**INVITATION TO TENDER “ITT” No. PS20200272
CONCRETE REPAIR - VANCOUVER SOUTH TRANSFER STATION**

QUESTIONS AND ANSWERS NO. 1

ISSUED ON NOVEMBER 3, 2020

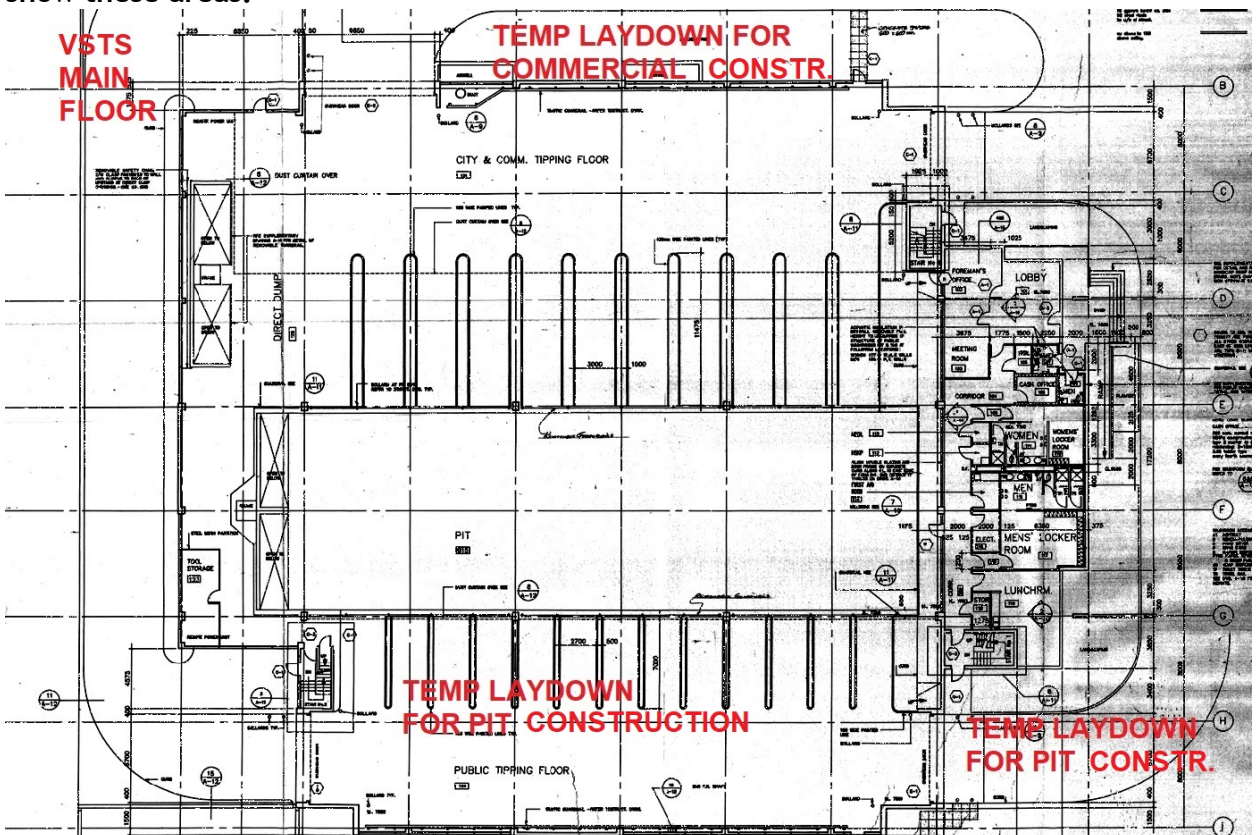
Q1	Question: Where is the laydown area?
A1	<p>The laydown area is under the commercial side tipping floor (16m by 48m). The area under the residential side tipping floor can also be used as laydown but only close to the south wall (approximately 3m by 16m). The area outside of the building, on the north side, can be used as a temporary laydown during the weekend construction period for the commercial side tipping floor, and it is approximately 16m by 4m. Finally, the residential side tipping floor and the outside eastern area can be used as a temporary laydown during the weekend construction period for the pit (this area can also be used by the concrete pumper if the contractor chooses to use one during the repairs). The attached figures show these areas.</p>

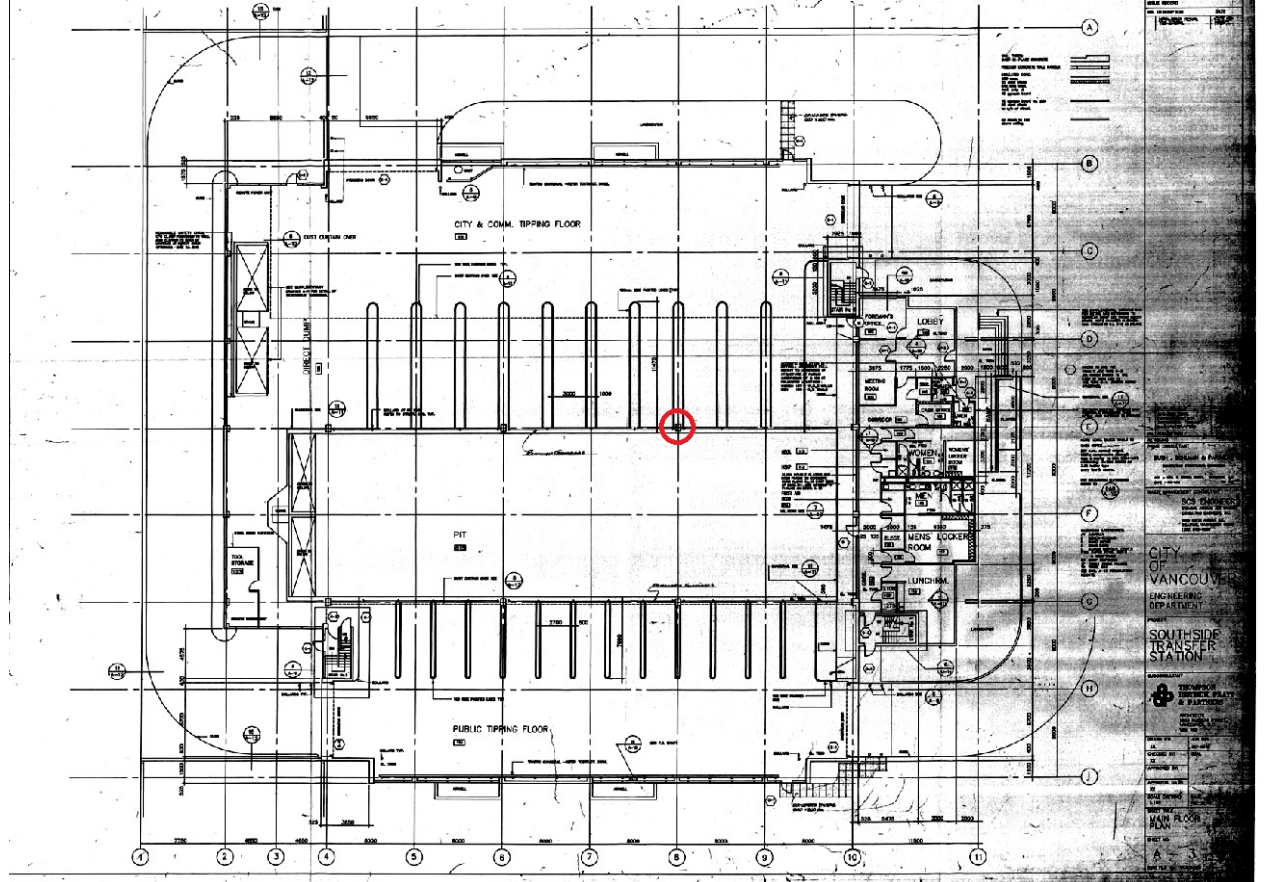
Q2	We are requesting a two week extension to the deadline for the above tender due to the delay in receiving the addenda promised at the site visit.
A2	Please see Amendment No. 2.
Q3	From reading the scope of work to be completed in the Pit (the middle of the pit, the topping on the rail section, as well as the provisional item to repair the bottom of the pit), it is our understanding that the entirety of this repair is to be done in one weekend between Saturday at 3am - Sunday at midnight. This is a great deal of work that needs to be completed. Is there the ability to break the work over more than one weekend? Would the facility consider a shut down of the pit area to complete the work consecutively instead of over a few weekends?
A3	An extra day will be given, in other words, the work can end on Monday at midnight instead of Sunday at midnight.
Q4	In Table 3 of the Statement of Work Document Inspection report Item 2.02 E8. There is no associated photo of this item, nor is it outlined in AECOM’s Remedial Work activity list. Please provide details on what and where this “concrete spall repair” is, and a photo of the repair.

A4	The photo is not supplied but it would be very similar to photo 0202(b): Column E6 and the repair procedure would be the same as well. The location is at E8 (i.e. 16m away from column at E6, it is one of the columns on the commercial side tipping floor, in

proximity to the pit edge). Please see below for the location:
